**CITY OF WINTER PARK
PLANNING AND ZONING BOARD**

**Staff Report
August 2, 2016**

SPR 4:16 Request of Shannon Calzada for approval to build an 820 square foot, one-story addition to the single-family home located at 1803 Barker Drive on Lake Spier.

CADWAY COTTAGES, 2281 NAIRN DR.
 WINTER PARK, FLORIDA
 PREPARED FOR:
UTILITY SITE PLAN

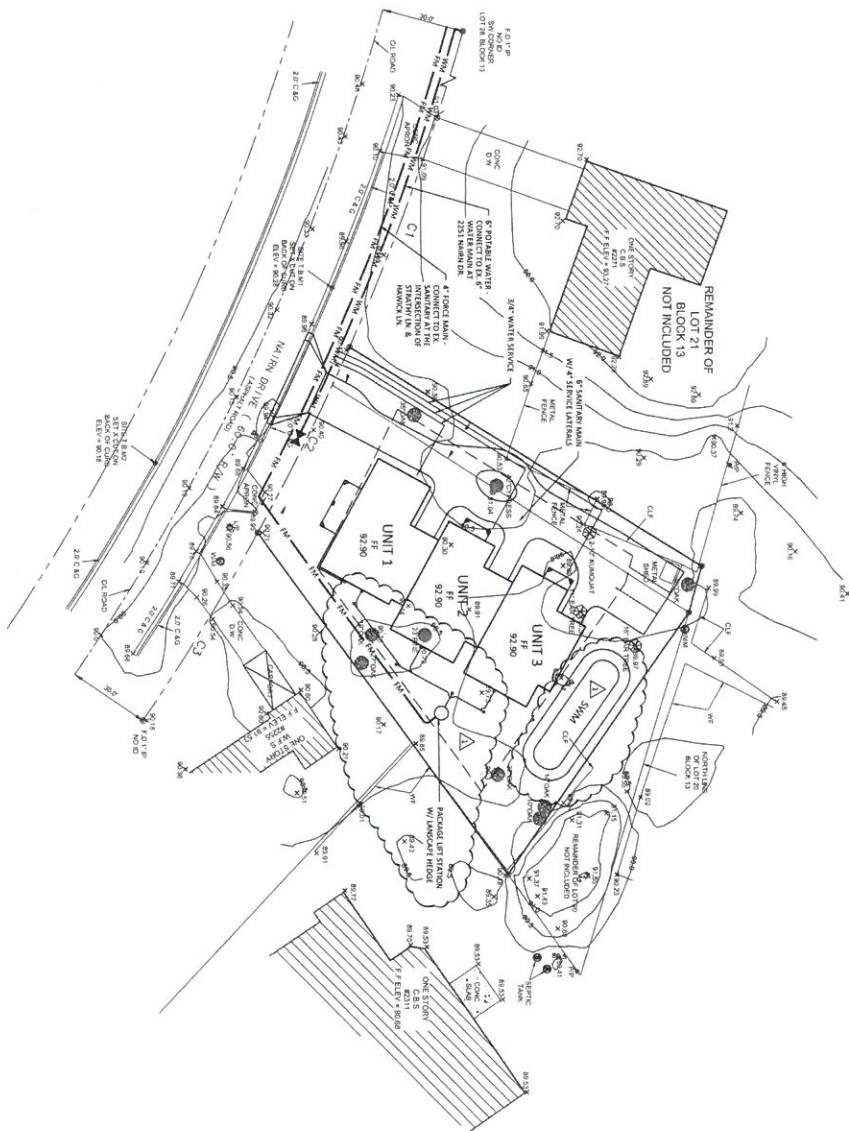
Special attention needs to be paid to the placement of the necessary sanitary lift station for the project. Currently, the plans show the lift station to the east of unit two and three which cannot be viewed from the street. Also, a landscape hedge is proposed to surround the lift station. As these plans are not final engineering drawings, if these items were to be moved to a location where they were visible from the street or adjacent properties, this would quickly diminish the visual appeal of the development. There are conditions recommended to address these circumstances.

Rev.	Date	Description	Chk By
1	7/7/16	REV LIFT STATION LOCATION, FM AND SAN SYSTEM ACROSS SWM	KJS
